工程指示 / 要求簡箋(E.I.)

工程指示編號：EI / 9626 / 18

工程名稱：觀塘裕民坊

工程項目：後裝窗大圖 更新

業特經貿有限公司
 MIDI ARCHITECTS & PLANNERS LTD.
 610 Che Kwo Ling Road, Kowloon
 Tel: 2368271-4 Fax: (852) 2727266
 DMC NO. : J837-IW-2502 REV. : B

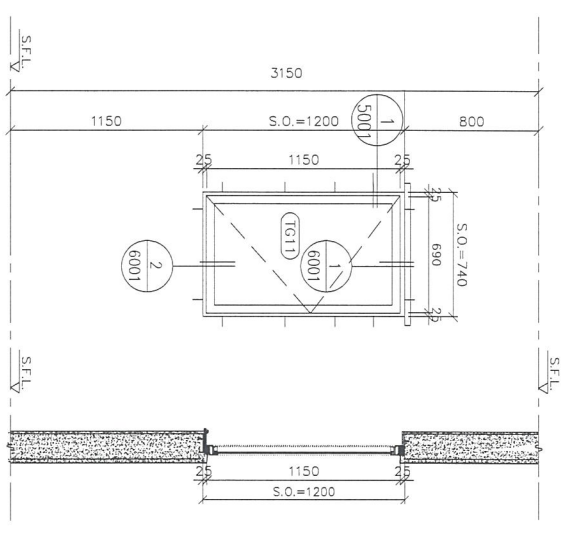
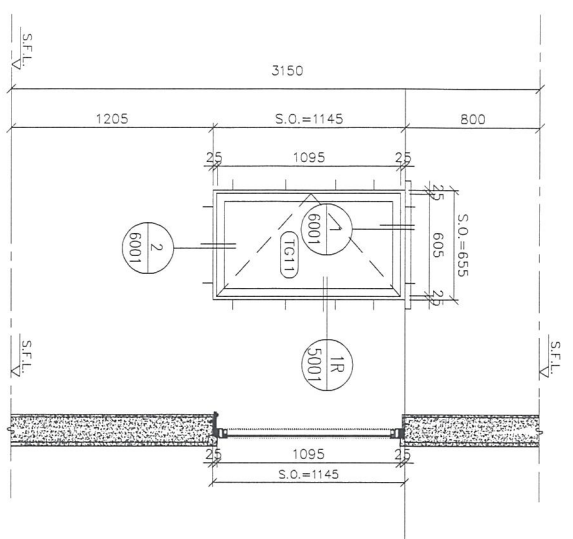
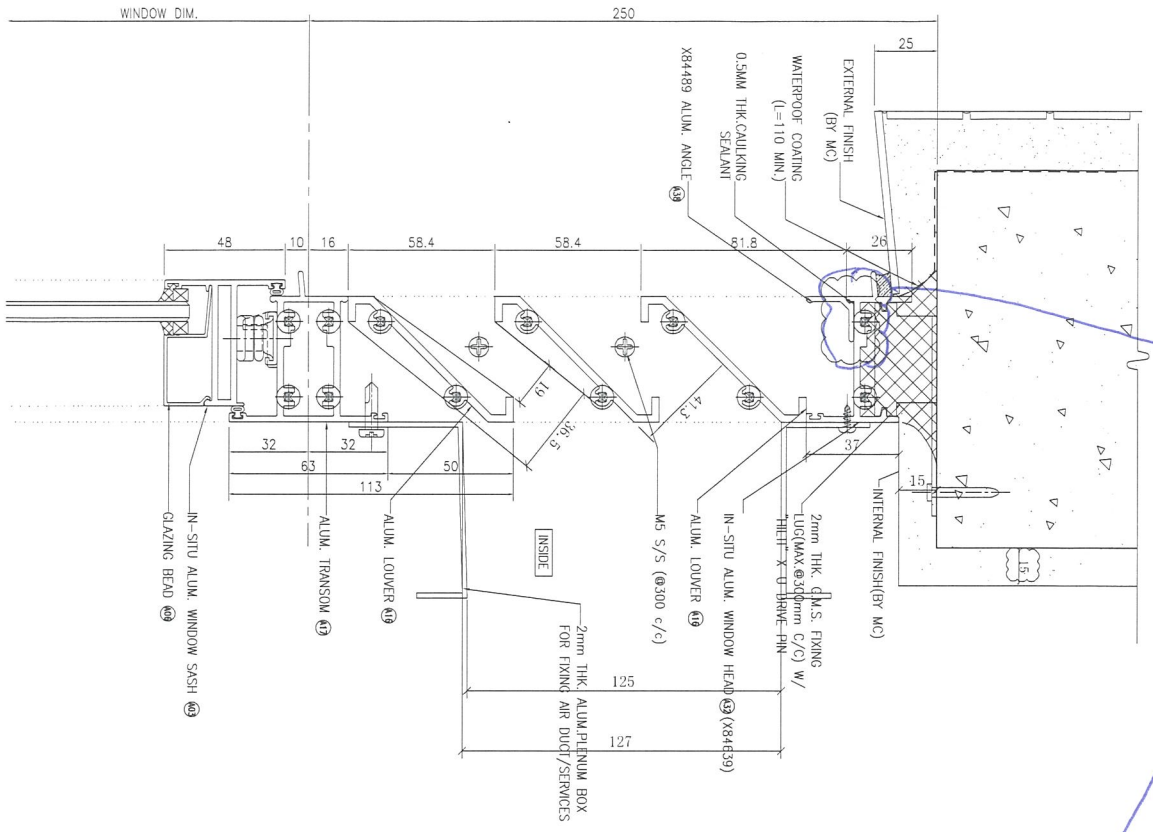
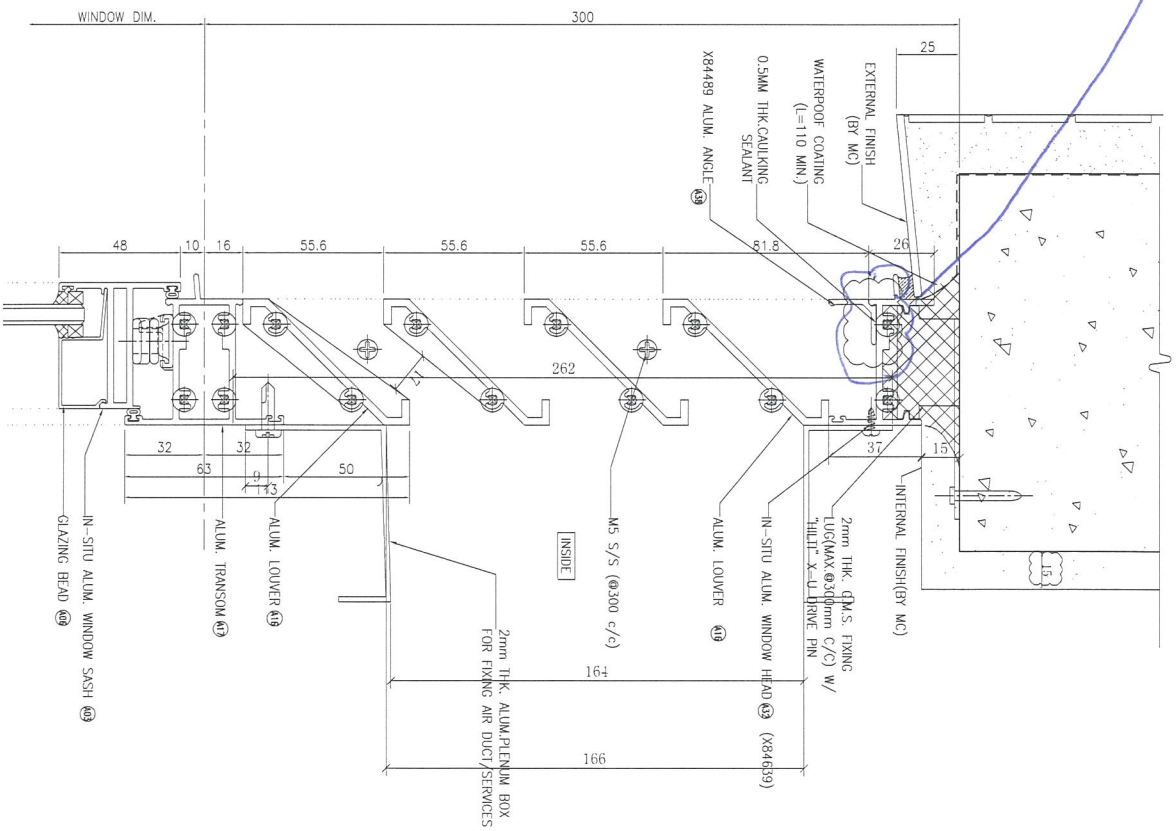
1. 修改 T5W/L-5 的玻璃類型
 2. 百葉擋水鋁角不收螺絲，改為唧膠固定
 3. 更改水線孔之位置
- 煩請修改拆圖，謝謝!

LOCATION : 15 6/F-26/F, 28/F-50/F FLAT L LIV.
 8mm THK AOD TIGED FROSTED TEMPERED GLASS

T5W
L-5
Insitu Win

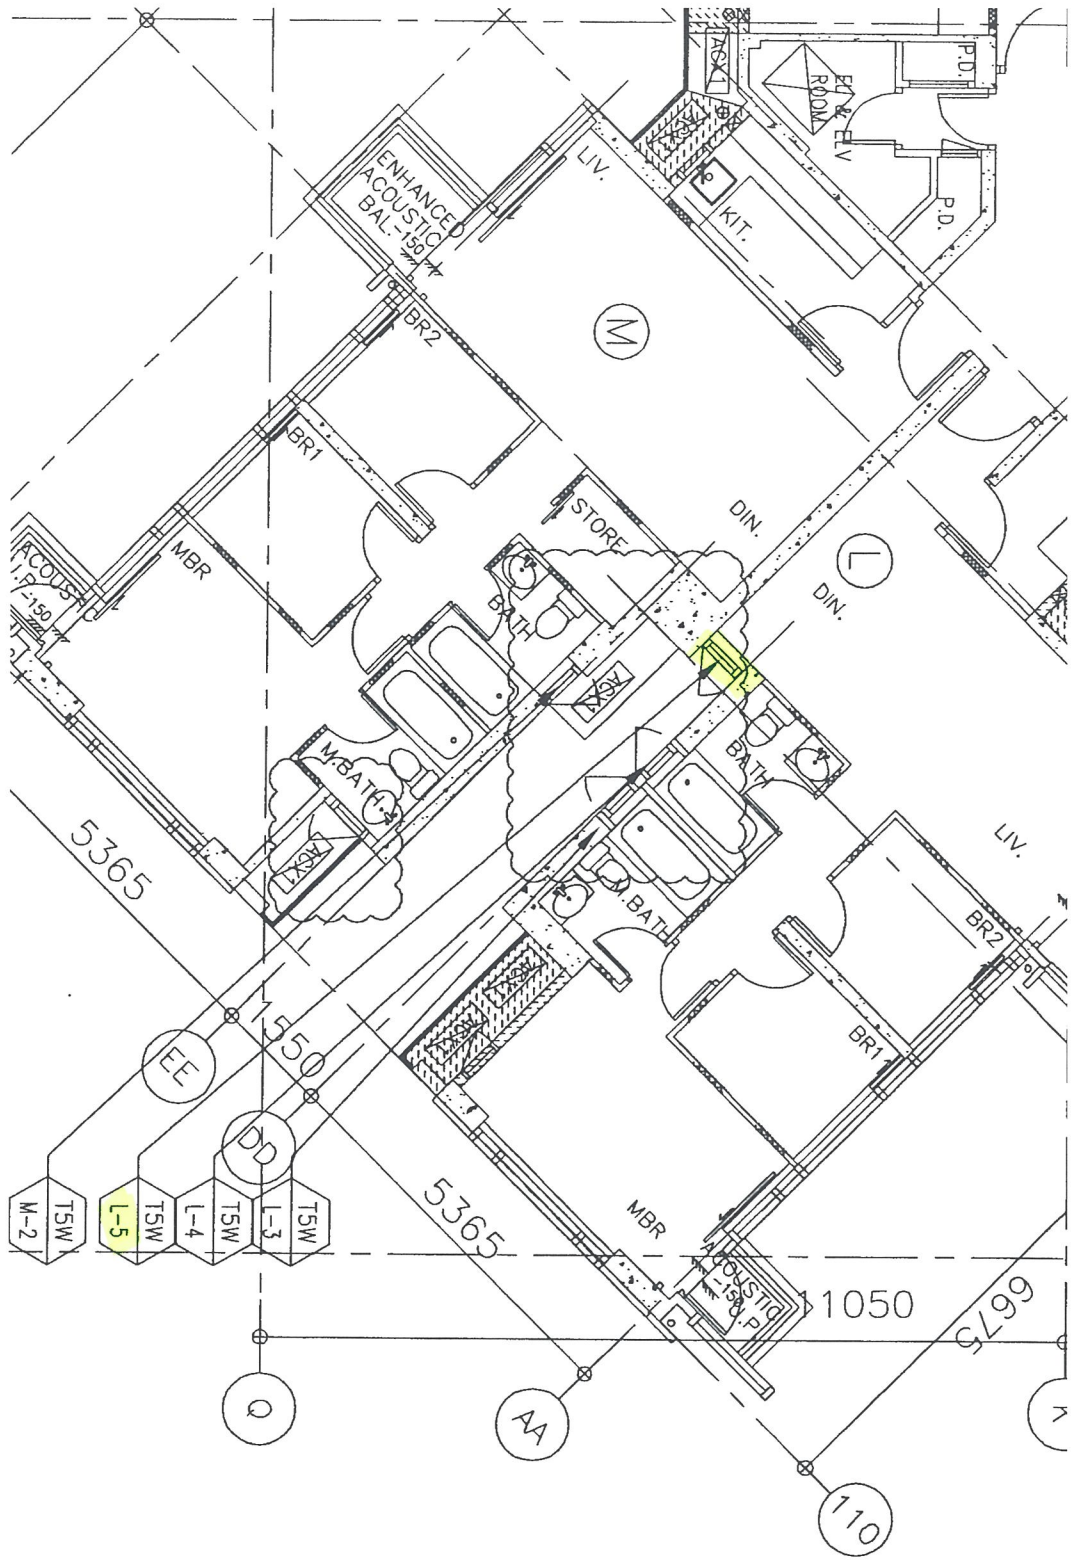
2018.11.16 meeting

① 玻璃 玻璃窗/L-5

玻璃
Acid-etch.
T5

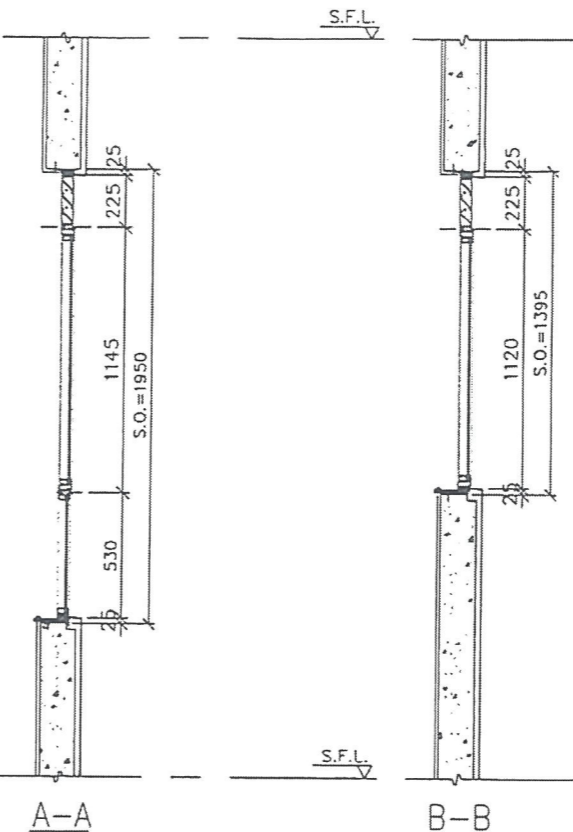
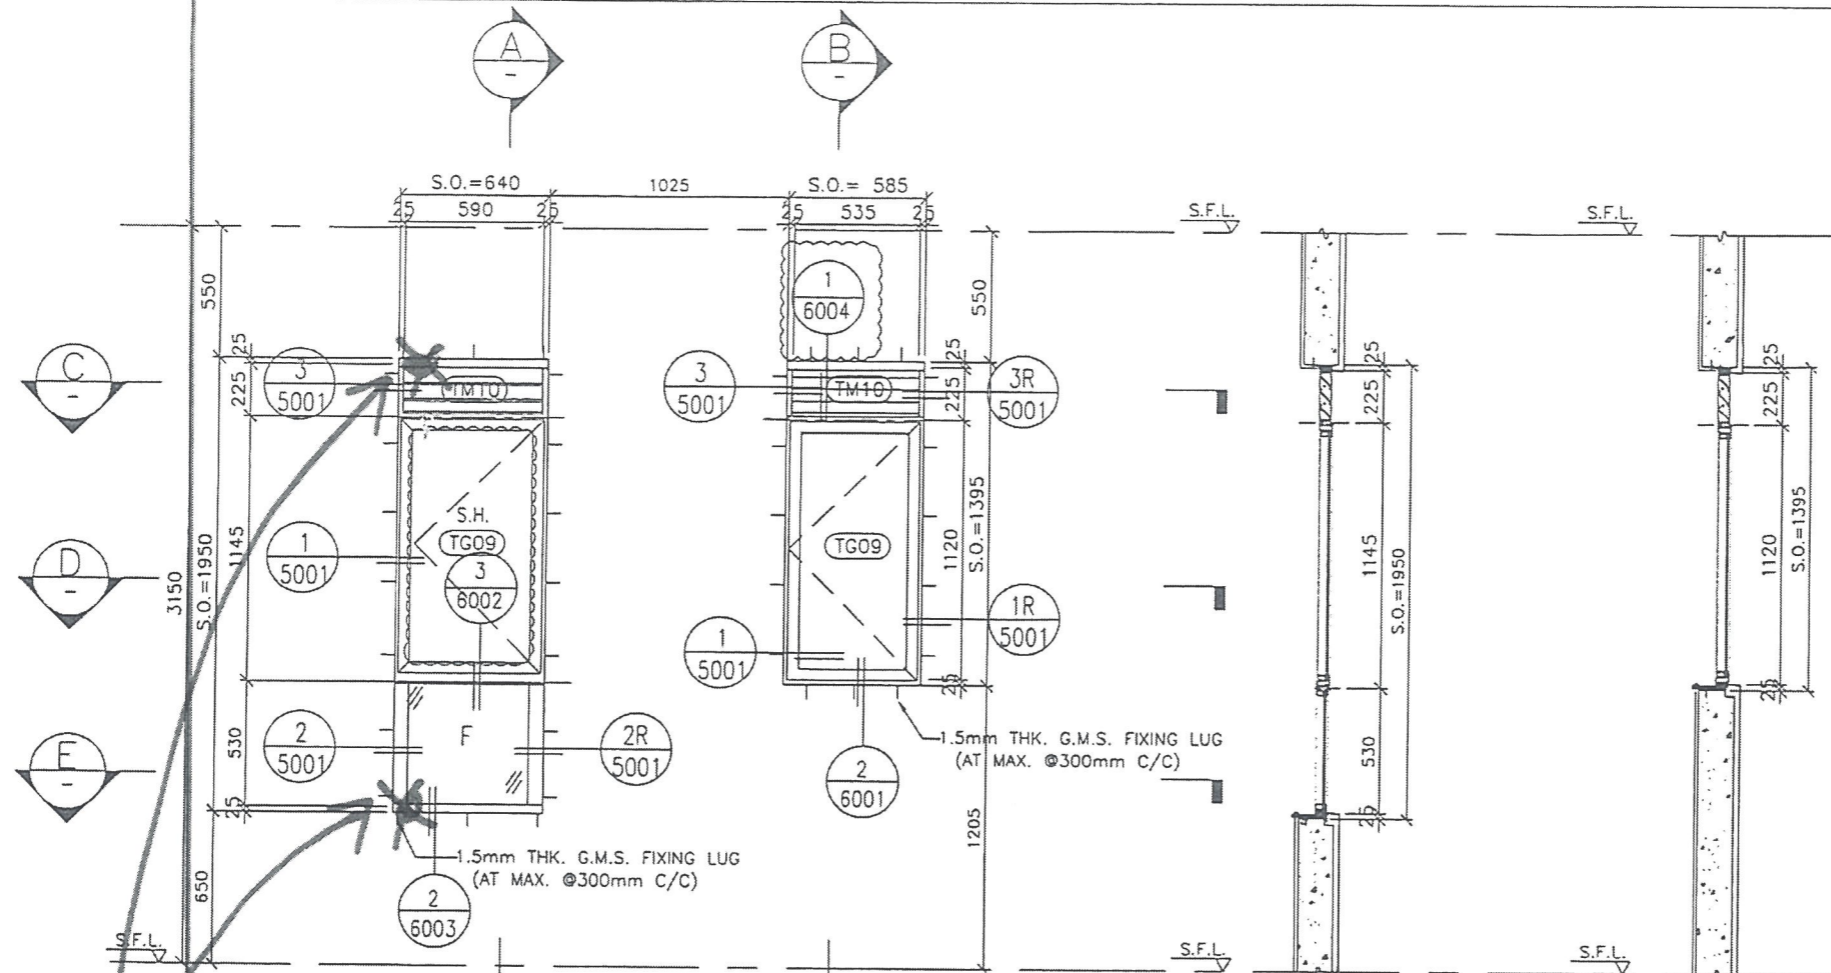
③更換水喉孔

The location and interfacing details of required bonding connection points for curtain wall and aluminium window & louvre were co-ordinated & confirmed and marked on the attached "Midi" shopdrawings and photo.
